Southern California Edison Company

Subject: Docket No. 50-206
Emergency Plan
San Onofre Nuclear Generating Station
Unit 1

ENCLOSURE 1

SAN ONOFRE UNIT 1 EMERGENCY PLAN

FIGURE 5-1 STATION ORGANIZATION

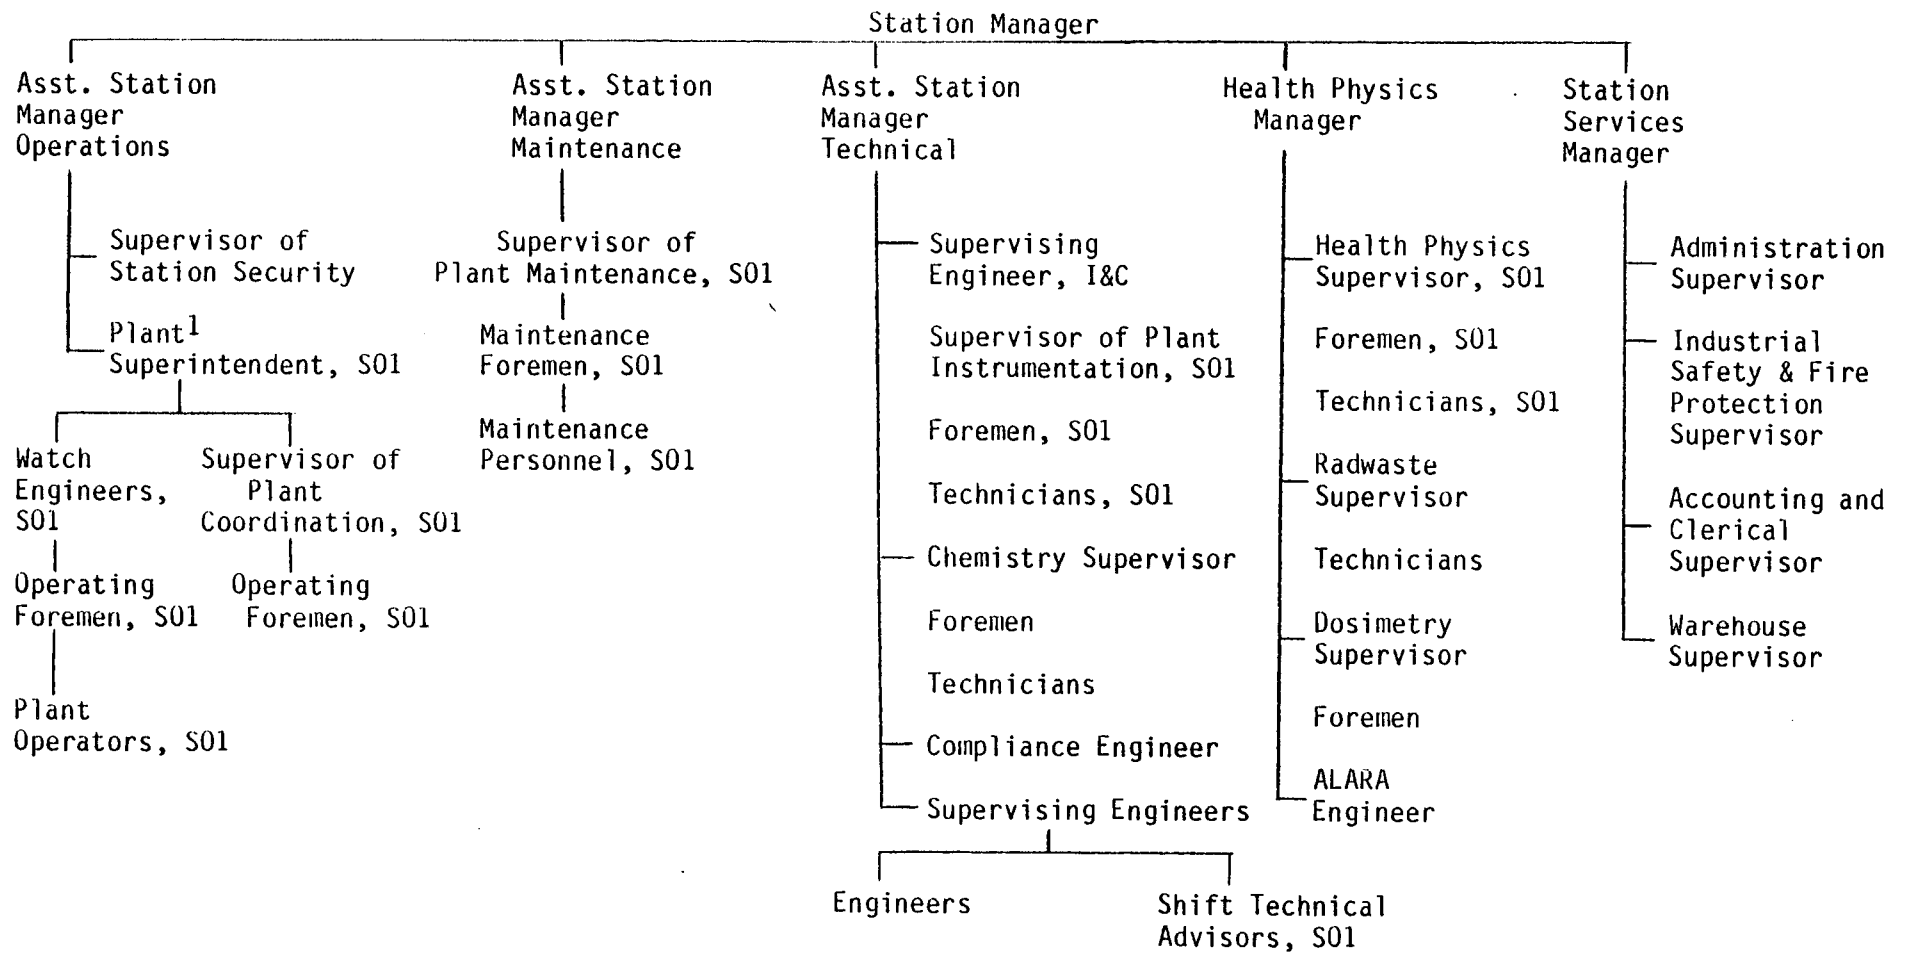
- B.3 The titles of persons who are in line to become emergency coordinators are confusing. For example, it is not clear if "Superintendent Unit 1" (p. 5-2) is the same as "Superintendent" (Figure 5.1), and the position "Nuclear Plant Manager" cannot be found in Figure 5.1.

Provided as Enclosure 2 are revised pages 5-1 through 5-18 of the San Onofre Unit 1 Emergency Plan. These revised pages clarify the succession of authority at the station and reflect currently effective position titles.
